**PLANNING AND ZONING COMMISSION, REGULAR MEETING  
THURSDAY, JUNE 11, 2026 - 6:00 PM  
COUNCIL CHAMBERS, CITY HALL  
910 S. FRIENDSWOOD DR., FRIENDSWOOD, TX 77546**

**A. PRELIMINARY PLAT: SHERRY LANE PHASE 2 STREET DEDICATION (APPROX. 800 FEET OF ROADWAY)**

**B. PRELIMINARY PLAT: GEORGETOWN BLVD PHASE 2 STREET DEDICATION (APPROX. 1450 FEET OF ROADWAY)**

PRELIMINARY PLAT  
SHERRY LANE PHASE 2  
STREET DEDICATION

PRELIMINARY PLAT  
**GEORGETOWN BOULEVARD  
PHASE 2  
STREET DEDICATION**

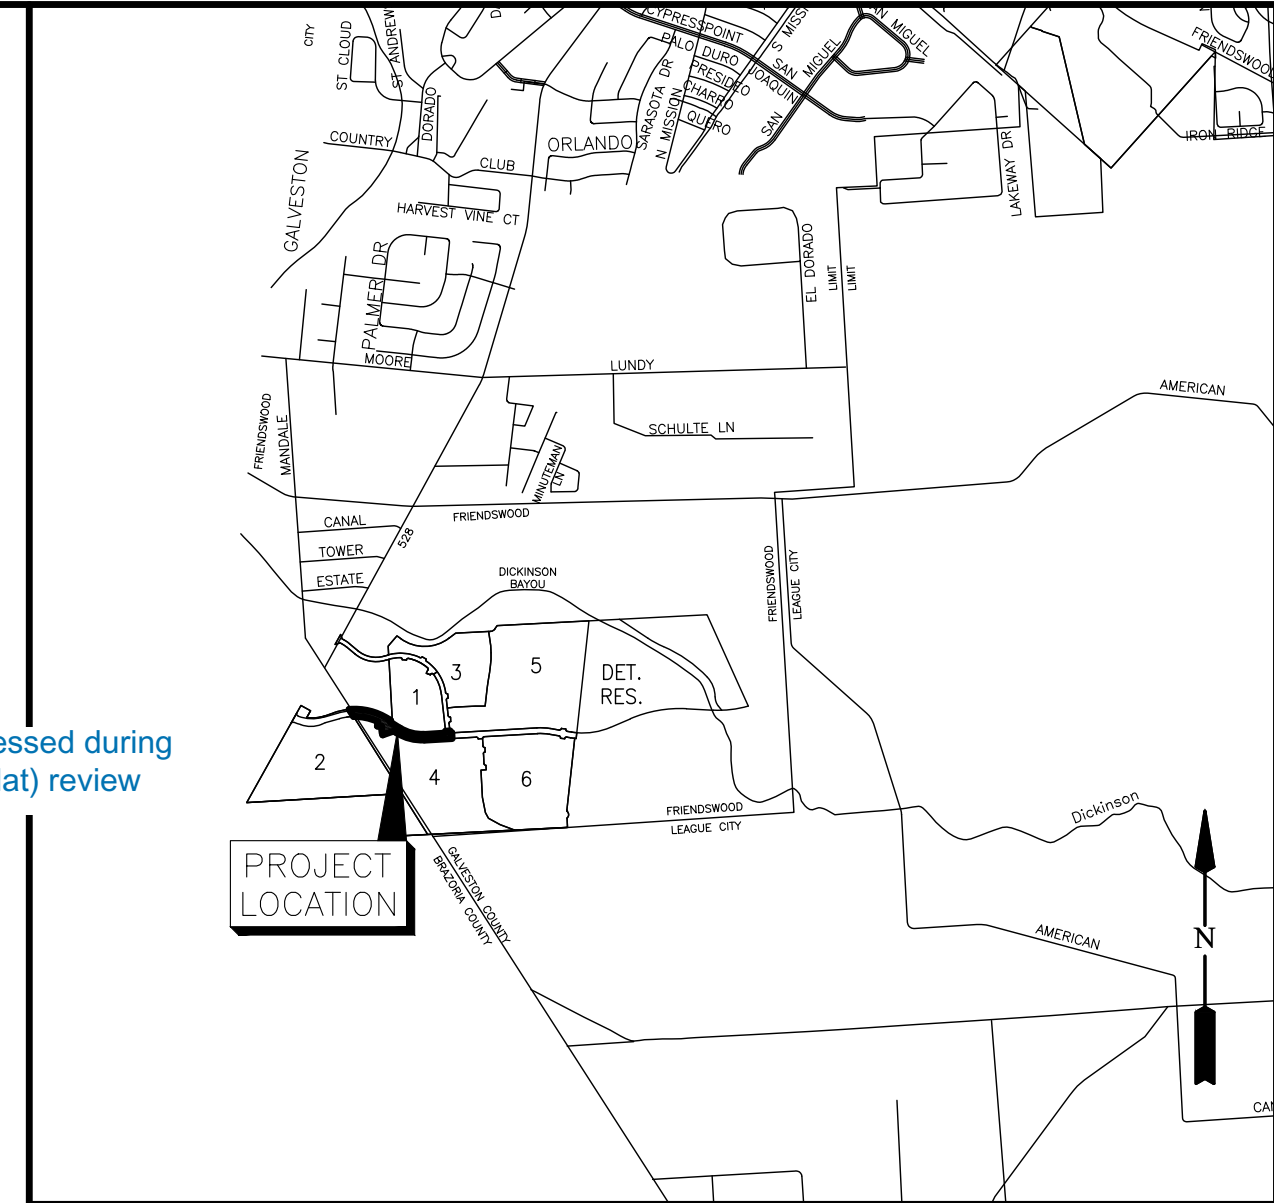
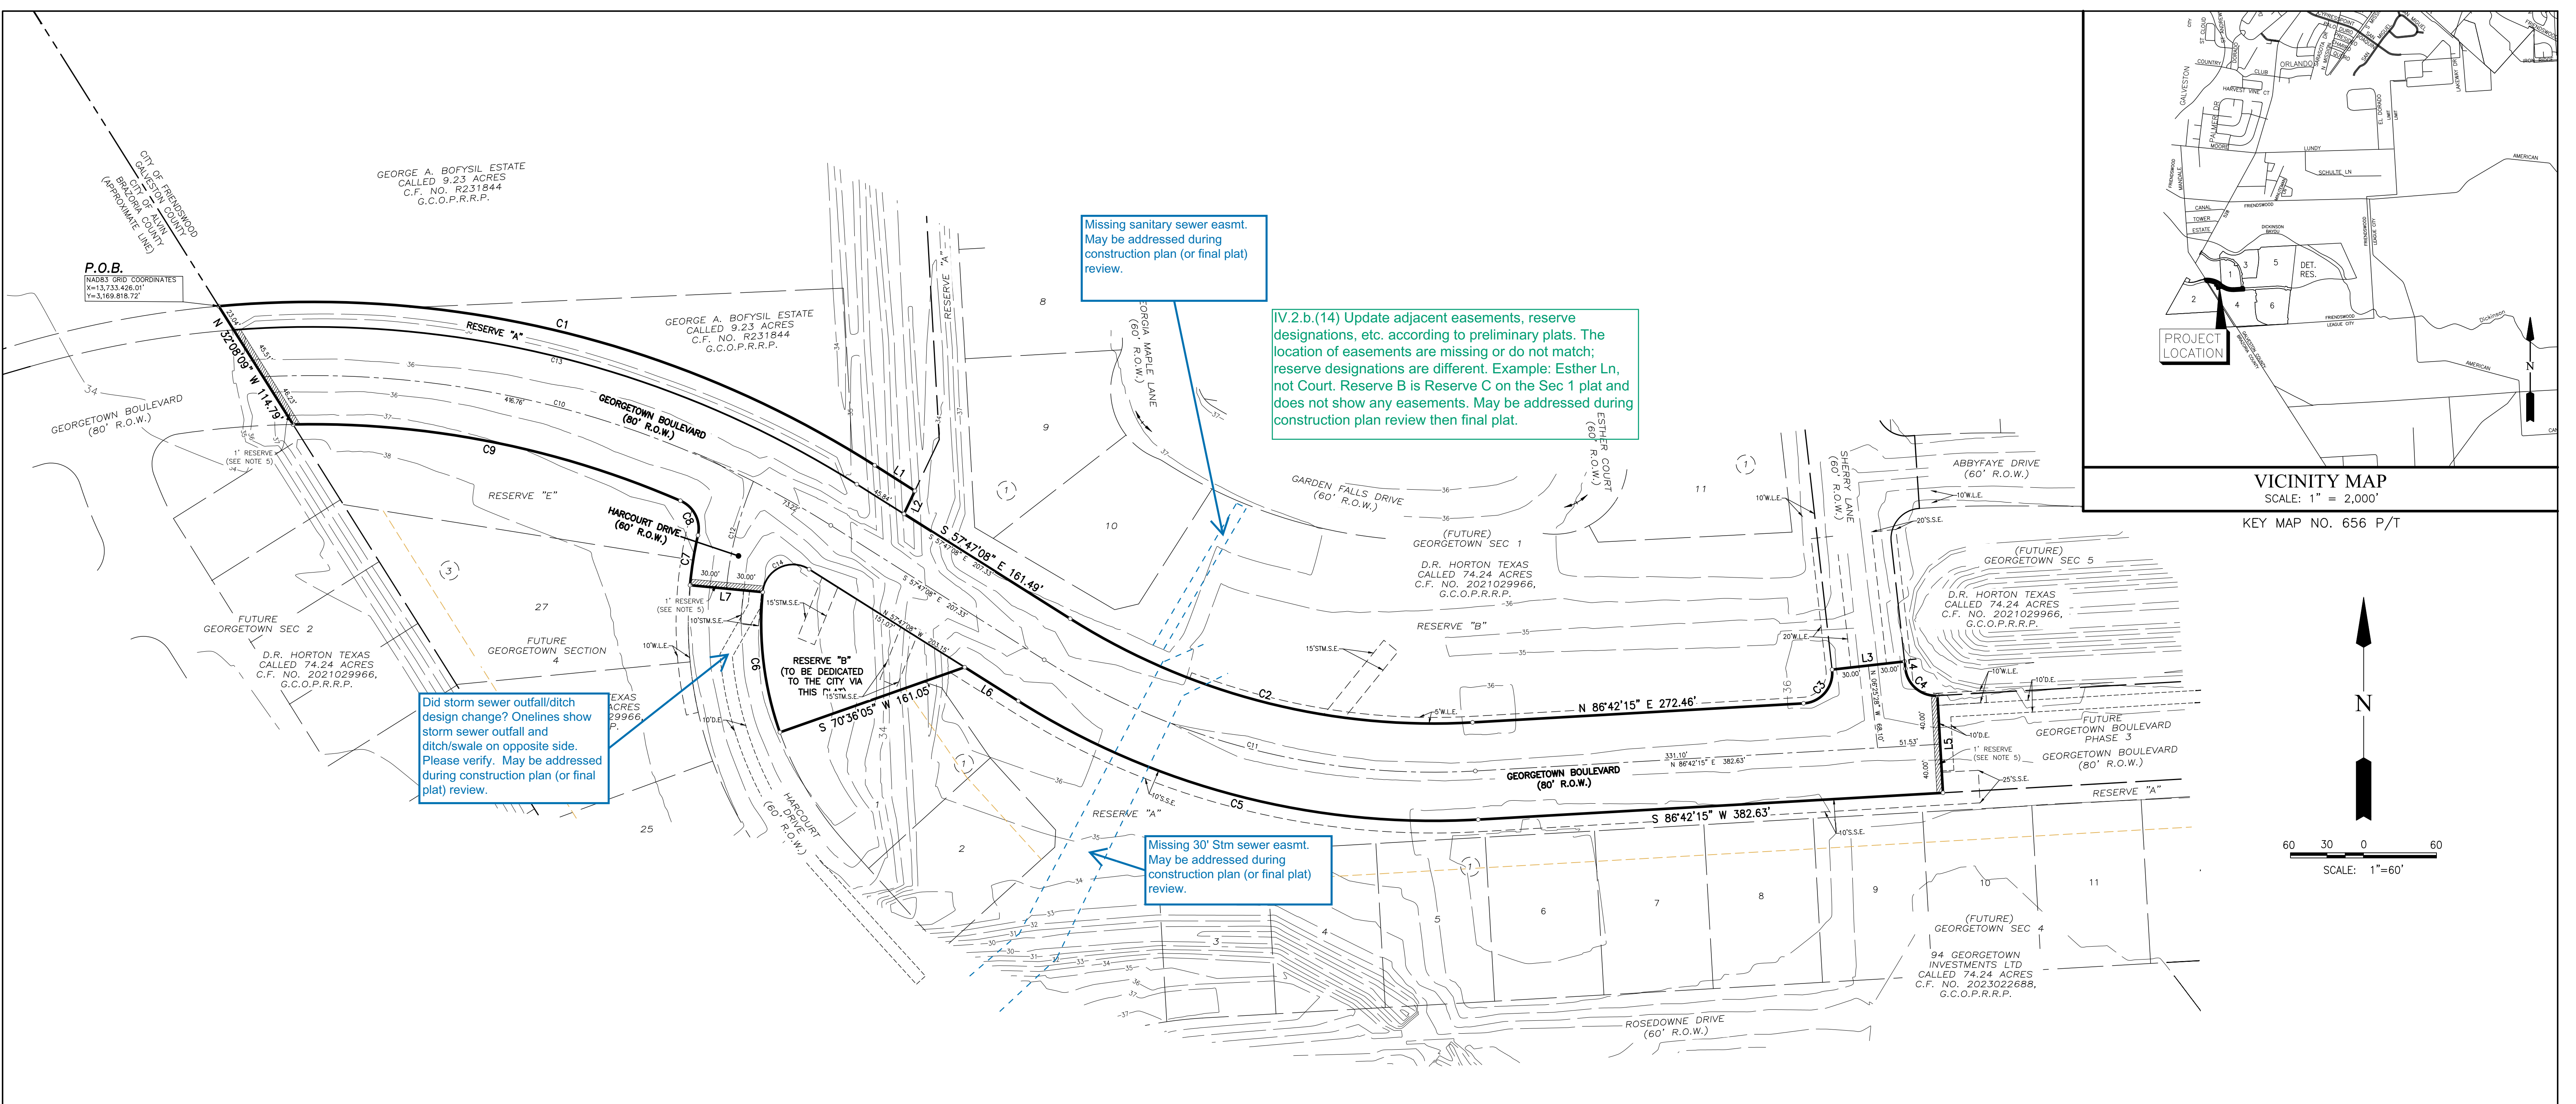
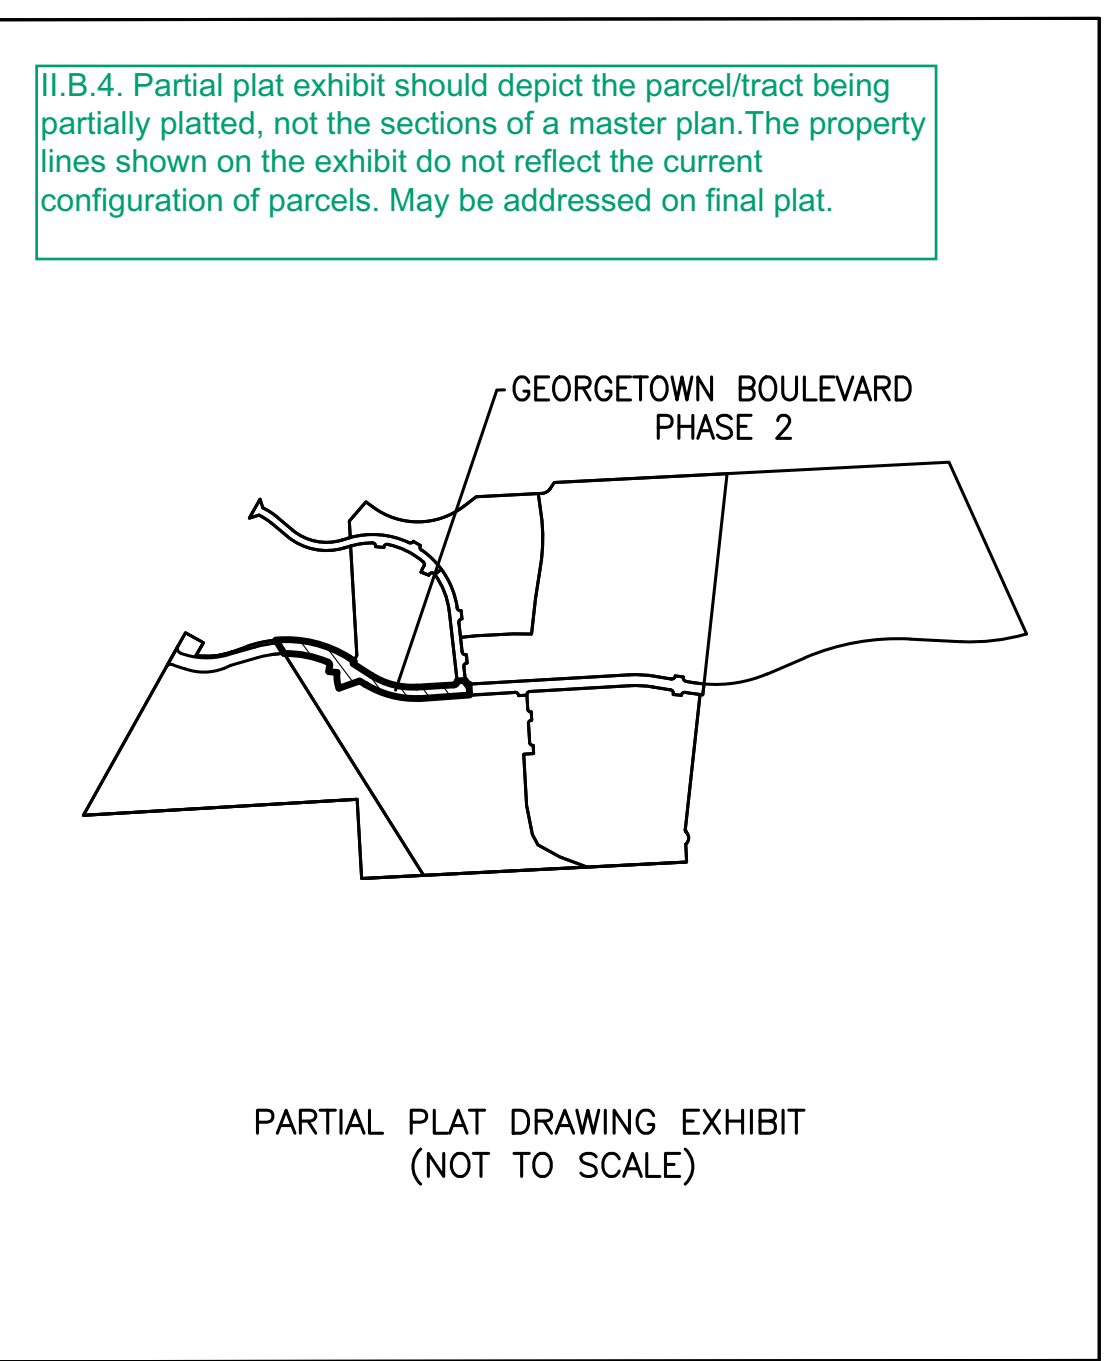
IV.2.b.(1)(d) Georgetown Blvd Ph 2 appears to be wholly within parcel deeded to DR Horton. Verify whether 94 Georgetown Investments is a vested owner. May be addressed at final plat.

IV.2.b.(18) Clarify whether or not pipelines exist within the plat boundary. Title report lists Southtex Pipeline #2021029970. Identify the pipeline location on the plat drawing. If this is a blanket easement, then please specify. May be addressed during final plat but if pipeline exists, it must be identified on the construction plans.

Please verify. May be addressed during construction plan (or final plat) review

Did storm sewer outfall/ditch design change? Onelines show storm sewer outfall and ditch/swale on opposite side. Please verify. May be addressed during construction plan (or final plat) review.

Missing sanitary sewer easmt. May be addressed during construction plan (or final plat) review.

IV.2.b.(14) Update adjacent easements, reserve designations, etc. according to preliminary plats. The location of easements are missing or do not match; reserve designations are different. Example: Esther Ln, not Court. Reserve B is Reserve C on the Sec 1 plat and does not show any easements. May be addressed during construction plan review then final plat.

Missing 30' Stm sewer easmt. May be addressed during construction plan (or final plat) review.
